Byers Gill Solar
Local Impact Report - Landscape and Visual Amenity
Darlington Borough Council

July 2024

Glenkemp Landscape Architects

1.1 Glenkemp Landscape Architects has been appointed by Darlington Borough Council (DBC) to prepare this Local Impact Report on landscape and visual amenity matters in relation to the Byers Gill Solar development. Glenkemp was initially appointed in July 2023 following publication of the Preliminary Environmental Information Report (PEIR) in May 2023. Glenkemp undertook a review of the proposals and methodology set out in the PEIR and advised Darlington Borough Council through subsequent (topic specific) consultations with the Developer. This document sets out the Council's response to the proposals and predicted landscape/visual amenity effects described in the Developer's Environmental Statement (ES). It forms part of the overarching Local Impact Report prepared by DBC as required under the application process for a Nationally Significant Infrastructure Project (NSIP). Primarily it deals with potential impacts which occur within the Darlington administrative boundary but also describes impacts affecting adjacent local authorities where relevant

Figure 6. Village settings and connecting highway in 500m zone

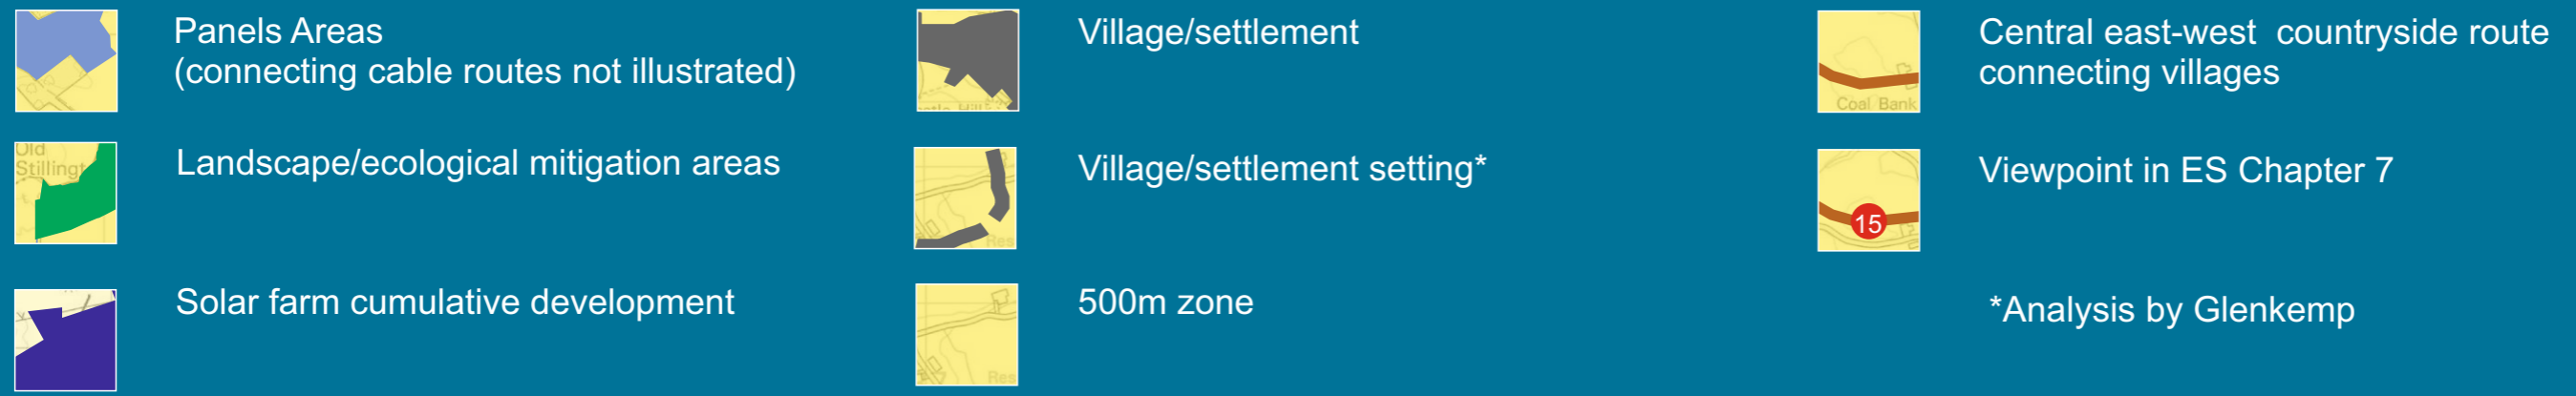
- 8.7 DBC also has concerns about the limited selection of photographs taken from the main east-west route in the Study Area connecting the villages. Figure 6 shows the location of the five ES viewpoints on the 10.6km long road corridor. Example C in this report illustrates alternative views from the section of highway between Bishopton and Great Stainton. Photograph 4 in Example C shows the view towards Great Stainton from the eastern approach. This view is not presented in the ES but it clearly shows a significant part of the setting of Great Stainton, visible from the highway, which will be affected by the Development. It is clear from photographs presented in Example C that viewpoint 21 in the ES is not representative of views available from this section of road.

Example A. Landscape analysis - Brafferton

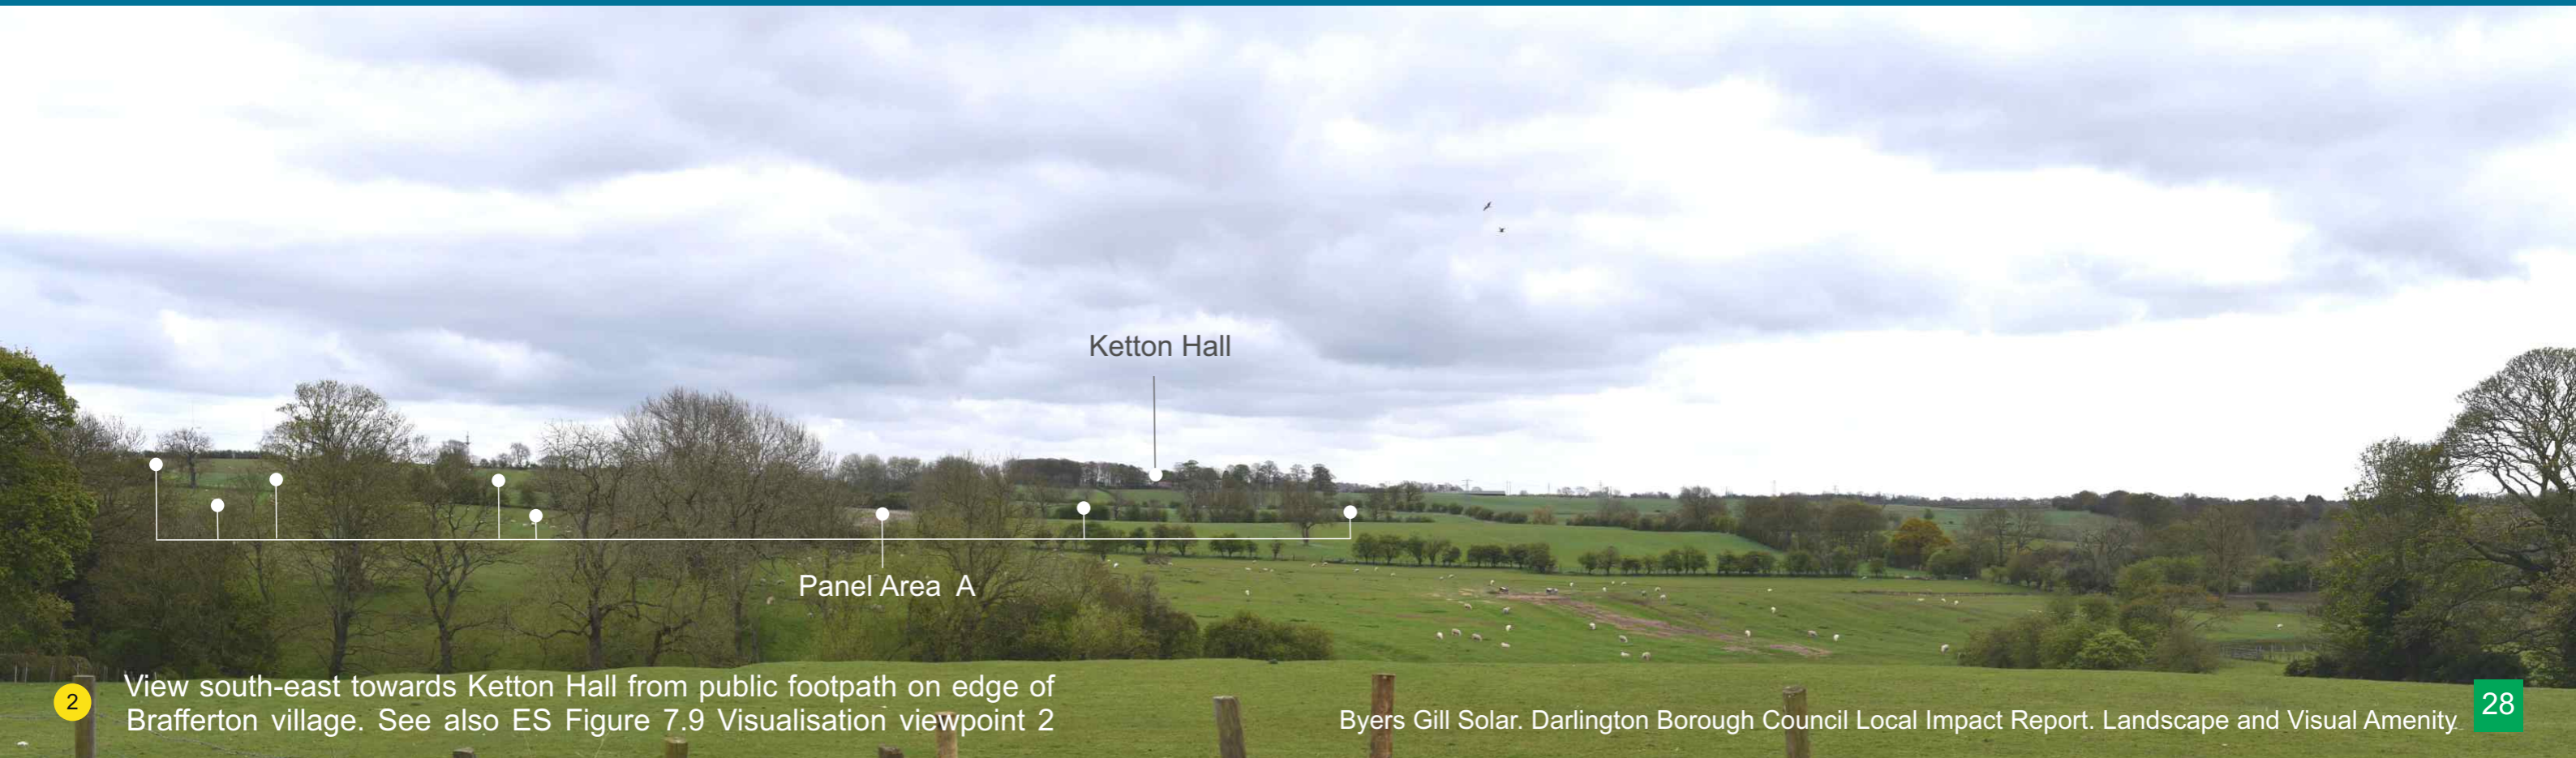
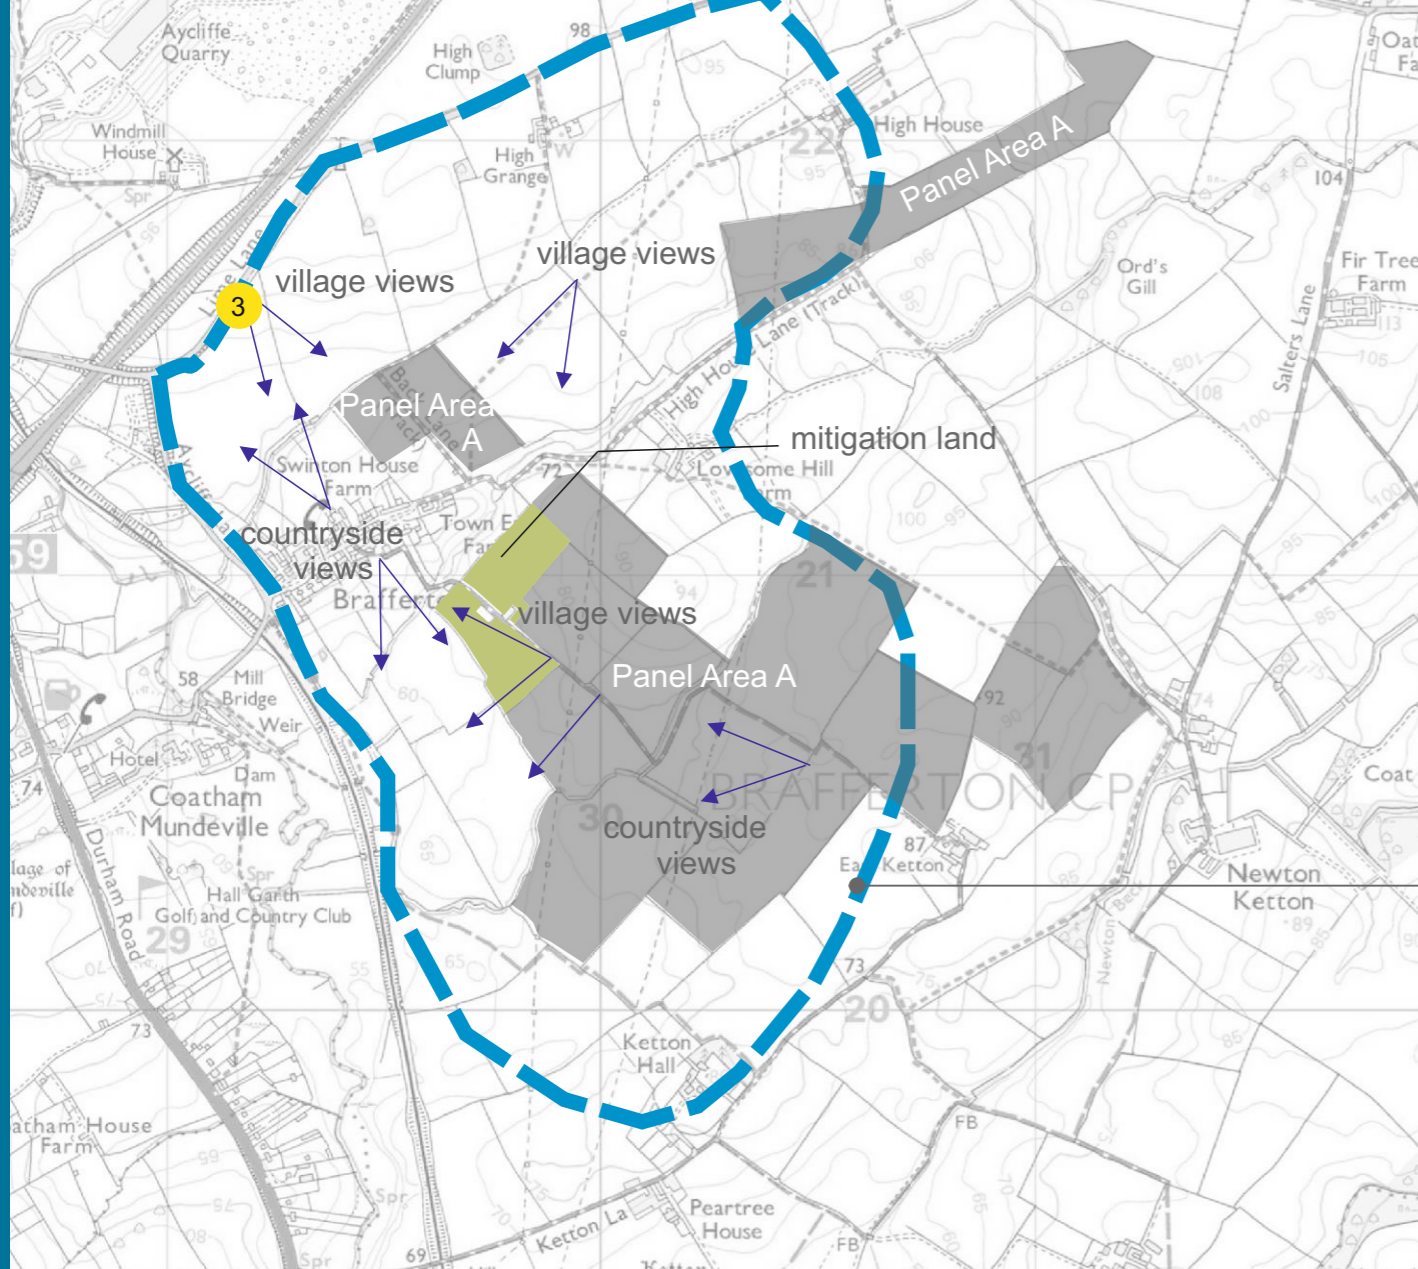
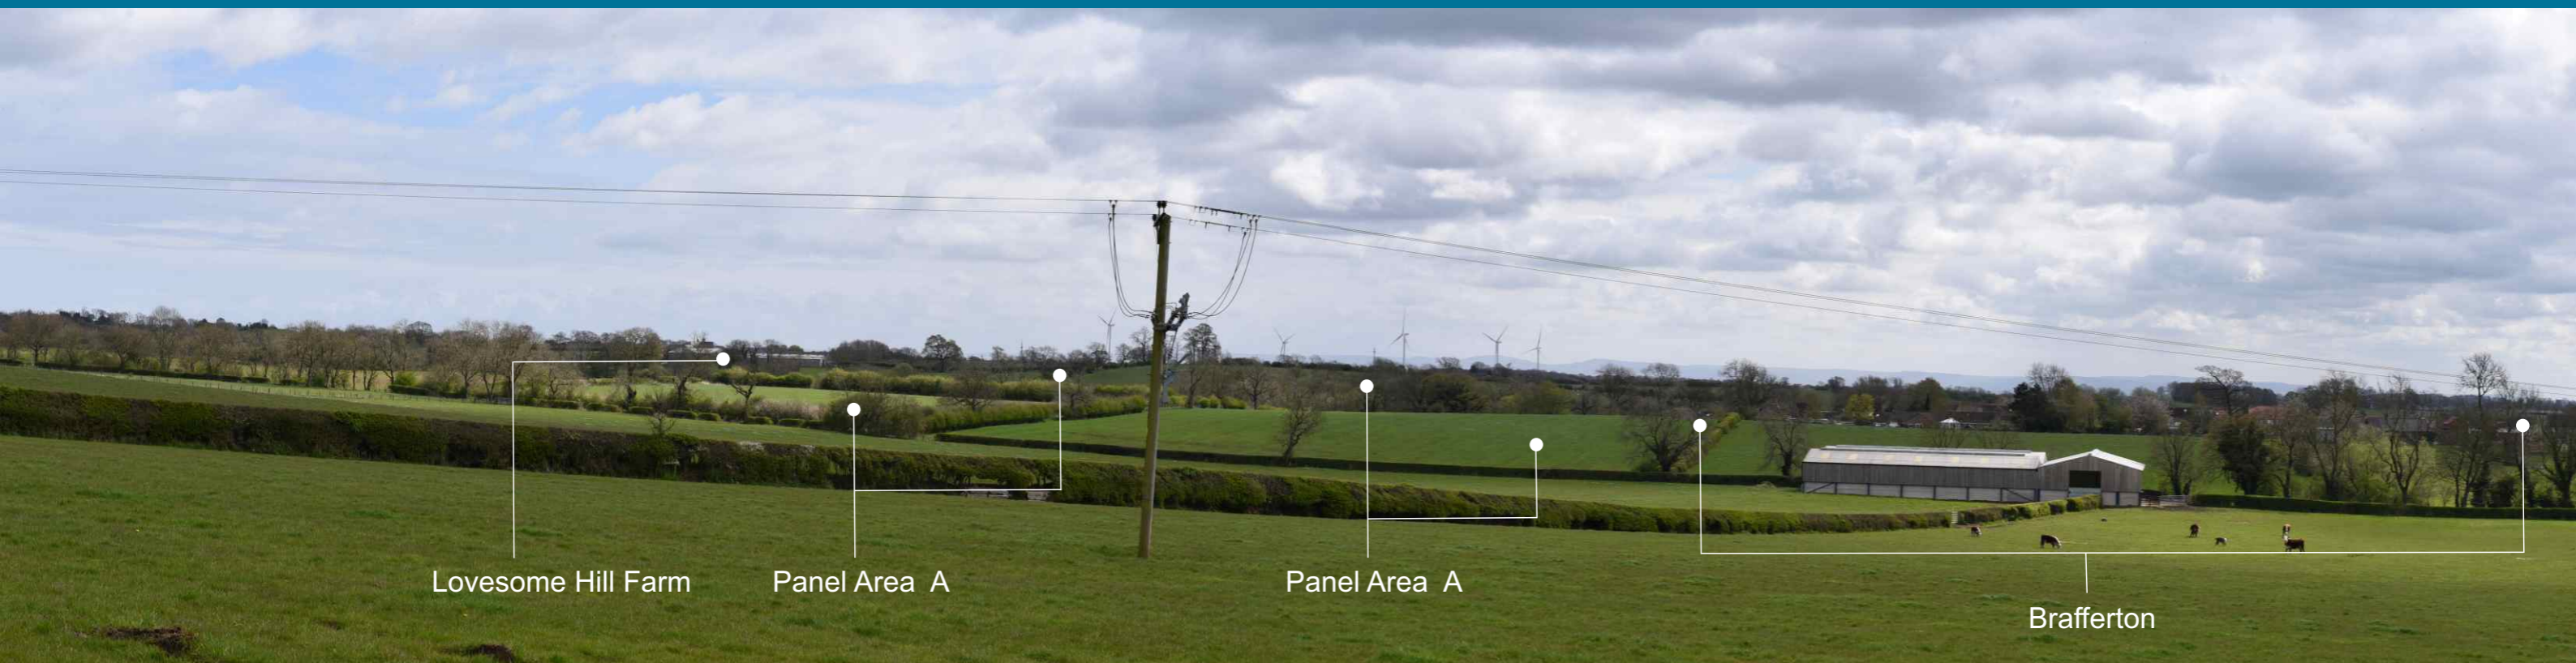
- 8.9 DBC is concerned that ES Figure 7.6 significantly understates the extent of the village settings and in doing so disregards areas of solar panel which fall within the settings. This discrepancy would clearly lead to a conclusion which understates the impact of the Development on the setting of the three main villages. Example D in this report illustrates a preliminary assessment of the setting around Bishopton. This level of settlement assessment would be expected for any major planning application. The extent of the setting around Bishopton shown in Example D is based on a reasonable assessment of intervisibility between the settlement edge and surrounding countryside. The assessment clearly shows that Panel Area E substantially falls within the village setting and would affect the magnitude of change within the setting.

- 8.10 DBC has also undertaken an assessment of the extent of land forming the setting of Brafferton and Great Stainton. See Figure 6 and Example A in this report. It is notable that ES Figures 7.6.1 – 7.6.3 show a more limited area than presented in this report. The DBC assessment is based on fieldwork, analysis of the ES photography and other photography presented in this report. Special note was taken of viewpoints 1 and 2 in the ES to define the setting area of Brafferton. There is no explanation in the ES as to why the ES photography was not used to identify the additional area of land within the setting of Brafferton to the north and south of the village, when it is clearly illustrated in the viewpoints. It is clear to DBC that the extent of the setting of the main villages is more extensive than shown in ES Figures 7.6.1 – 7.6.3 and, as a result, the effects of the Development on the setting (character) of the villages will be of a greater magnitude than assessed in the ES.

Extent of village setting observed through site photography and fieldwork and further confirmed by viewpoints 1 and 2 - ES Figure 7.9

Example B. Great Stainton - viewpoint analysis

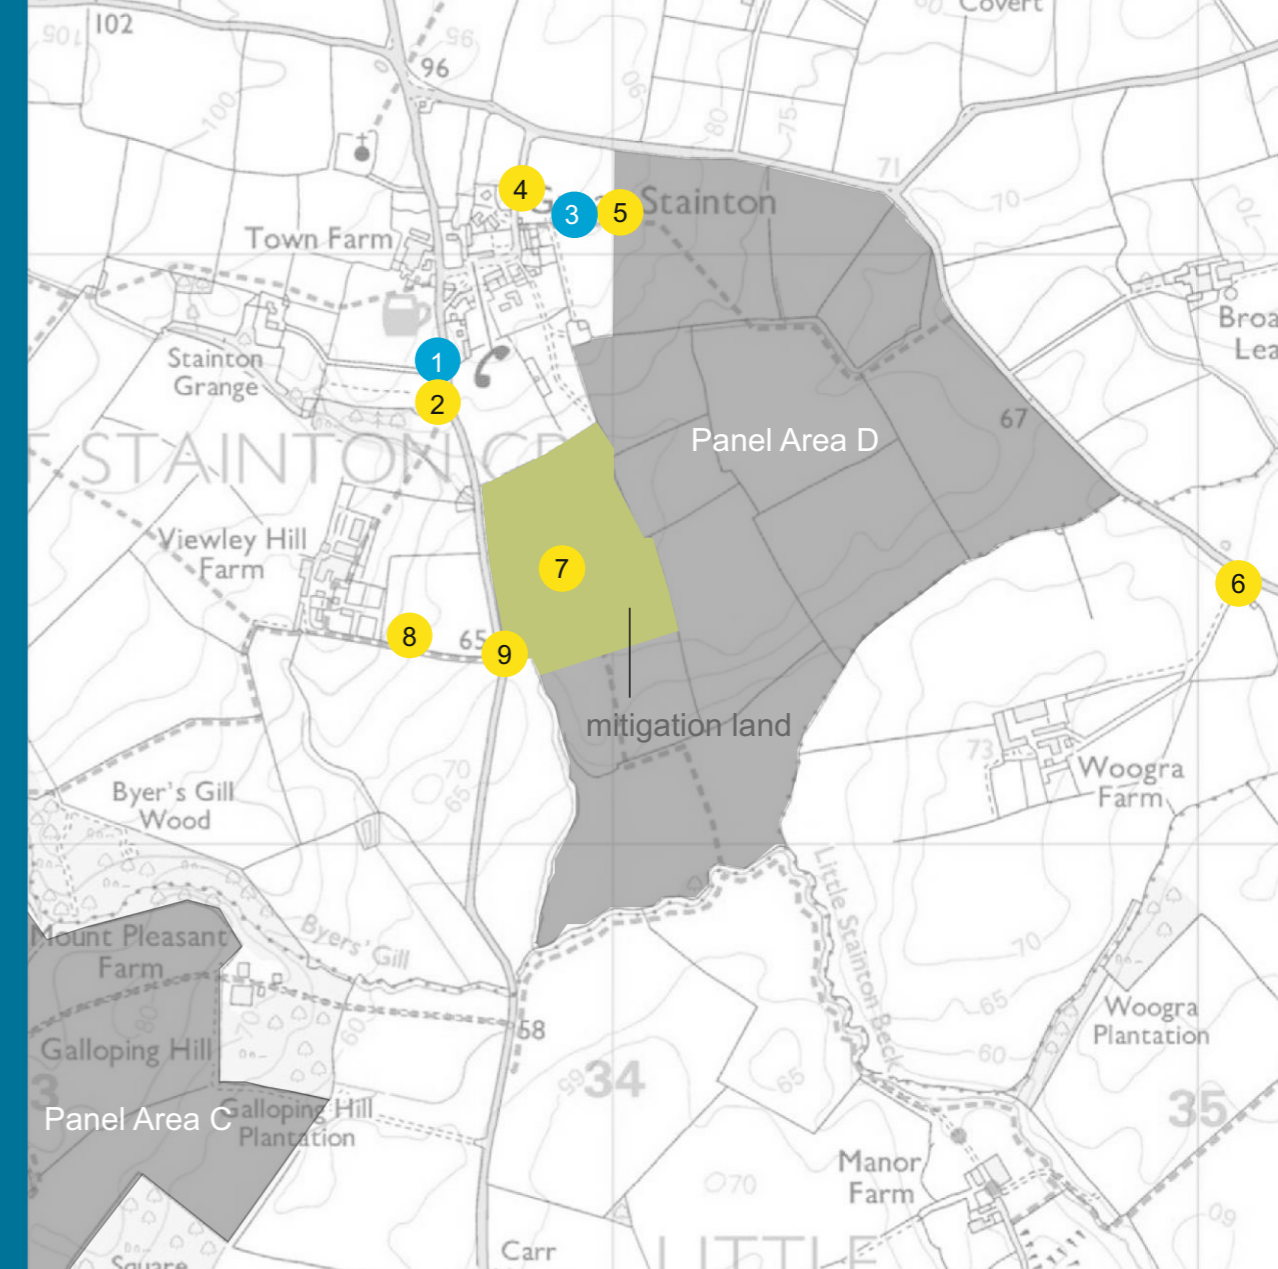
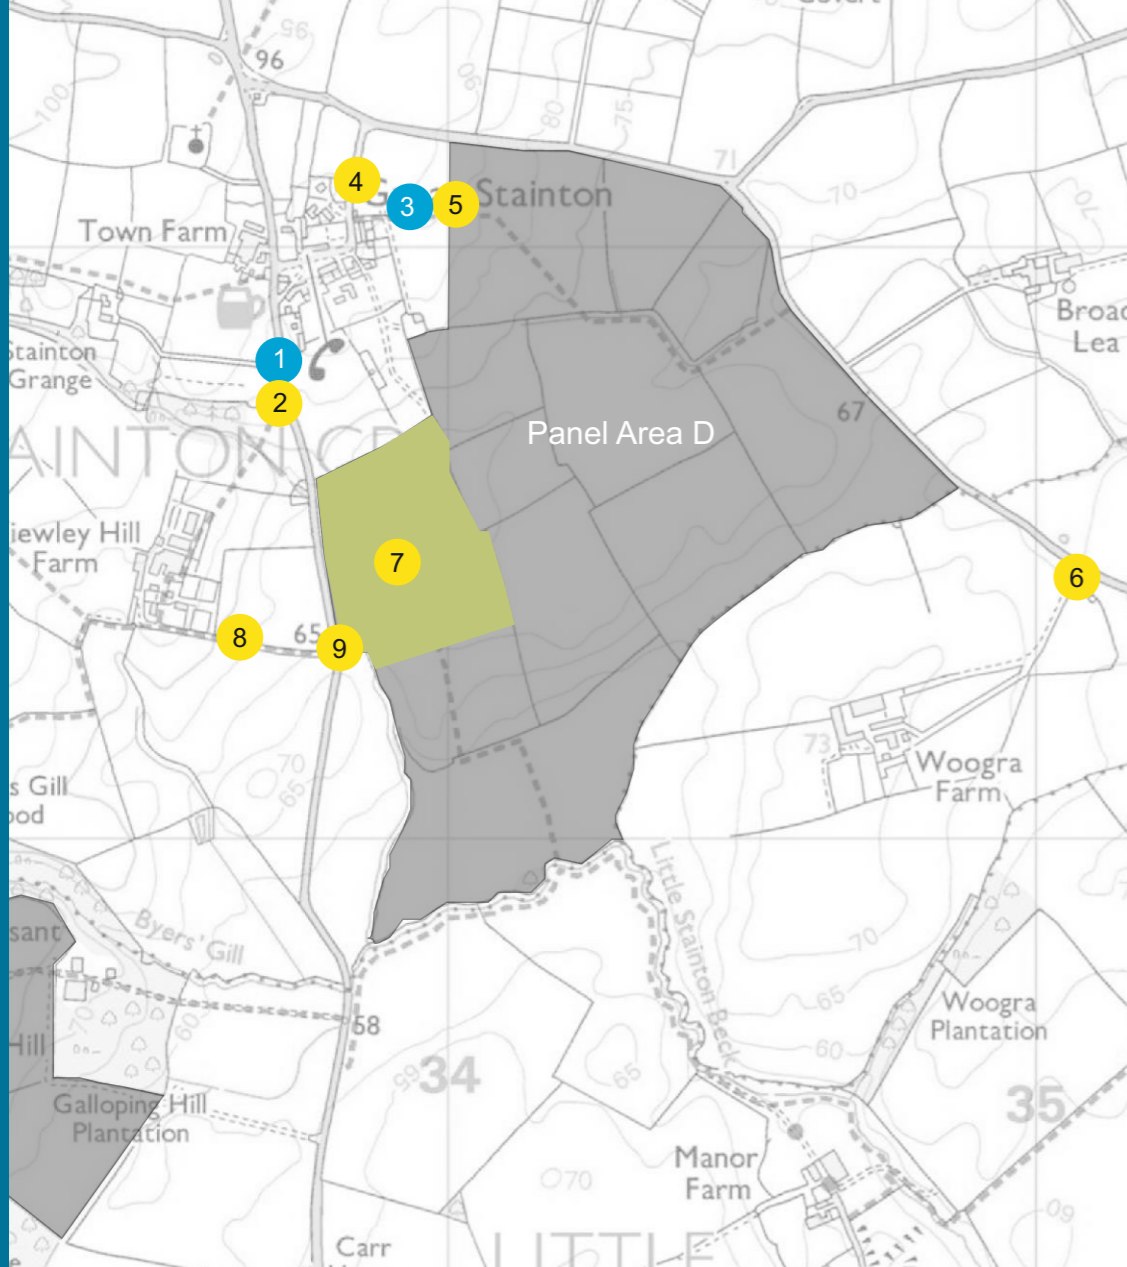
a) DBC are of the view that the photographic viewpoints in ES Chapter 7 do not represent the reasonable worst-case scenario which may be experienced by all receptors. DBC has particular concerns about views provided around Great Stainton and views from the east-west highway route connecting the villages. Furthermore, many of the photographs are taken in low light conditions, either overcast or with significant cloud cover. In some views, key landscape elements are silhouetted against sunlit backgrounds. In other photographs, views are substantially obscured by **avoidable** foreground features. It is accepted that weather conditions during winter are not always favorable for photography, but it would be expected that a reasonable range of light conditions would be presented in the ES to show the varied appearance of PV panels in the visualisations and also the nature of views, as demonstrated in this report. It is DBC's opinion there was ample opportunity for multiple site visits throughout the design and ES process to ensure viewpoints could be photographed in appropriate light conditions.

2 Photograph 20m south of viewpoint 18 showing panoramic view from highway
